# Access Compliance Report

## Public Rights-of-Way

Intersection ID: 14851	Main Street: E_WORTHINGTON_AV	Cross Street: PARK_RD	Location: S
ADA ID: 89CBB5F302B8	Ramp Type: Perp	Initial Pass/Fail: Fail	Overall Compliance: No
Severity Score: 13.75			
Codes/Mitigation Info/Possible Solution		Field Measurements/Component Compliance

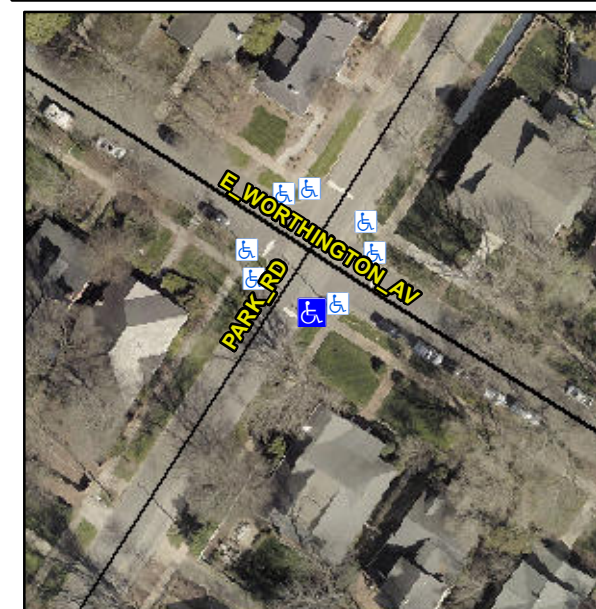
**Not Found, R304.2.2, R304.5.3**

Compliance	Description	Data	Compliance	Description	Data
N/A	Ramp Length (in)	50.0	No	Ramp Slope (%)	9.4
Yes	Ramp Width (in)	48.0	No	Ramp XSlope (%)	2.5
N/A	Flare Type LT	N/A	N/A	Flare Type RT	N/A
N/A	Flare Slope LT (%)	N/A	N/A	Flare Slope RT (%)	N/A
N/A	Flare Traversable LT?	N/A	N/A	Flare Traversable RT?	N/A
N/A	Landing Length (in)	N/A	N/A	DWS Provided?	N/A
N/A	Landing Width (in)	N/A	N/A	DWS Contrast?	N/A
N/A	Landing Slope (%)	N/A	N/A	DWS Length (in)	N/A
N/A	Landing X Slope (%)	N/A	N/A	DWS Full Width?	N/A
N/A	Landing Curb? (Y/N)	N/A	N/A	DWS Offset (in)	N/A
N/A	Shared Landing?	N/A			
N/A	Gutter Ponding?	N/A	N/A	Gutter Slope (%)	N/A
N/A	Gutter Lip Ht (in)	N/A	N/A	Gutter X Slope (%)	N/A
N/A	Painted X Walk1?	No	N/A	Painted X Walk2?	N/A
	X Walk 1 Direction	To NW		X Walk 2 Direction	N/A
N/A	X Walk 1 Width (in)	N/A	N/A	X Walk 2 Width (in)	N/A
	X Walk 1 Slope (%)	4.5		X Walk 2 Slope (%)	N/A
	X Walk 1 X Slope (%)	1.8		X Walk 2 X Slope (%)	N/A

**Remove & Replace Entire Ramp.**
